Cricklade Town Council

Cricklade Town Council's Planning, Conservation and Transport Committee 1st June 2026

- PL/2026/02134** **Site:** Land north and south of Stones Lane and north of Malmesbury Road, Cricklade, SN6 6JP
- Proposal:** Outline permission for up to 315 dwellings with associated access and infrastructure including Suitable Alternative Natural Greenspace. All matters reserved except for access
- Applicant:** Mac Mic Strategic Land Limited
- Closing Date:** 05/06/26 extension granted

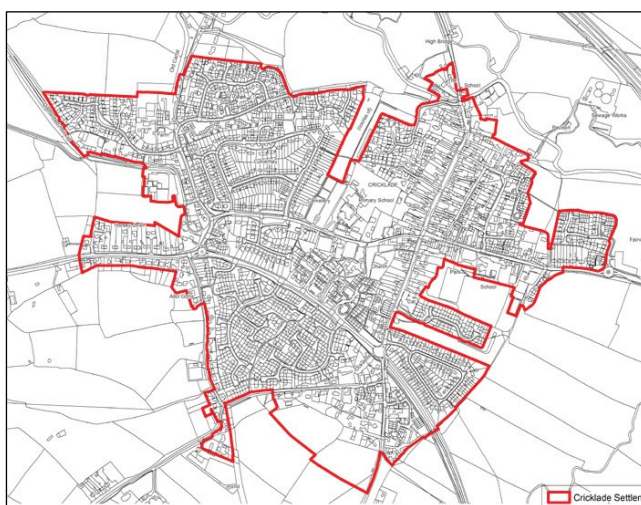
CTC agrees with the classification of Cricklade as a Local Service Centre
